SITE PLAN 2535 16TH AVE S MPLS MN

Two Story Base Floor Plans

**East Phillips Improvement Coalition**

May 13, 2008

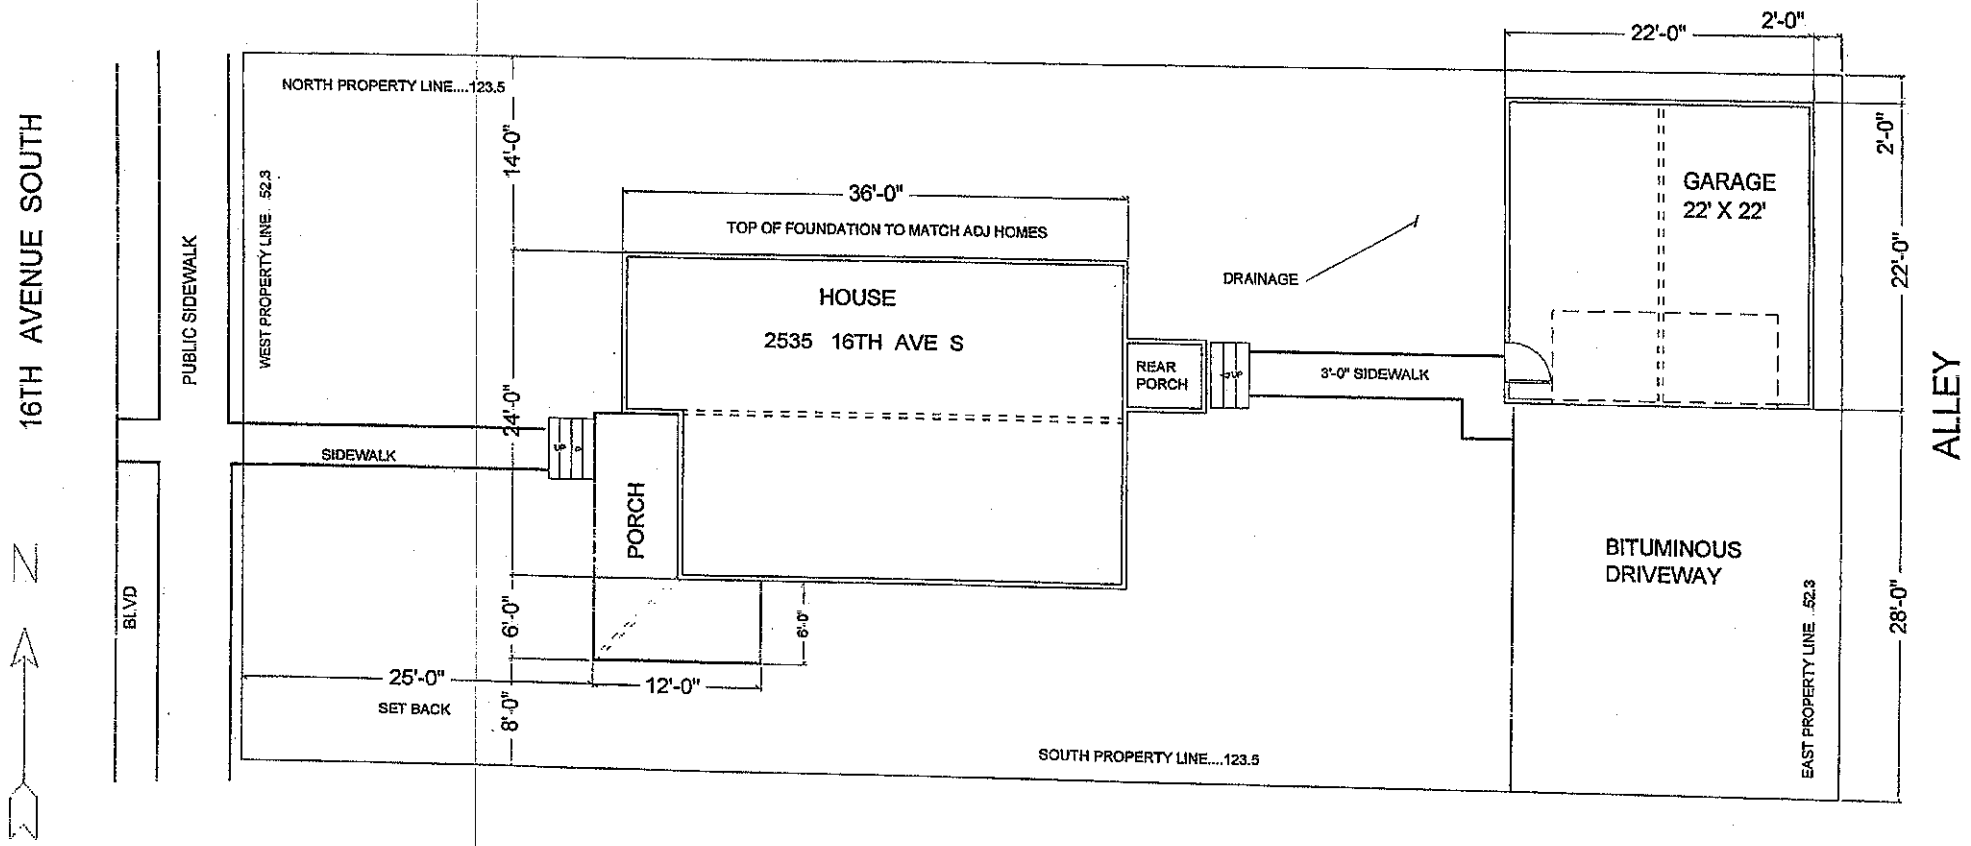
This letter is to inform you that the East Phillips Improvement Coalition (EPIC) voted unanimously at its membership meeting on Thursday, May 8th, 2008, to support the EPIC Board recommendation that the GMHC home shown in the plan sent to us by you for the lot at 2535 16th Ave. S. be built as specified with some additional features We ask that the building have first floor "visitability" for handicapped, meaning door widths be built wide enough for wheel chair accessibility. We also request that the porch go clear across the front of the house The site plan shows the porch going only halfway across the front of the building. However, the picture you sent accompanying your letter and plan shows it going all the way across We very much prefer the wider porch in the picture and doubt it would add much expense. We also would hope the bay window would be placed on the south side of the building to catch the sun

Last, we request that the builder seek a variance, if necessary, to move the house forward on the lot so that the porch front is in line with the other front porches on the block, i.e. the same distance from the street. This is both a safety concern and an aesthetic one, with the additional plus of a much larger back yard. We have found that seeing across backyards from house to house all the way down the block is a key safety feature as is avoiding niches in the front where crimes can occur when one house is deeply indented while the others are closer to the street. These are usual requests in this part of Phillips and we assume that the builders will value our interest and honor our requests. If there are any problems with these requests, please let us know
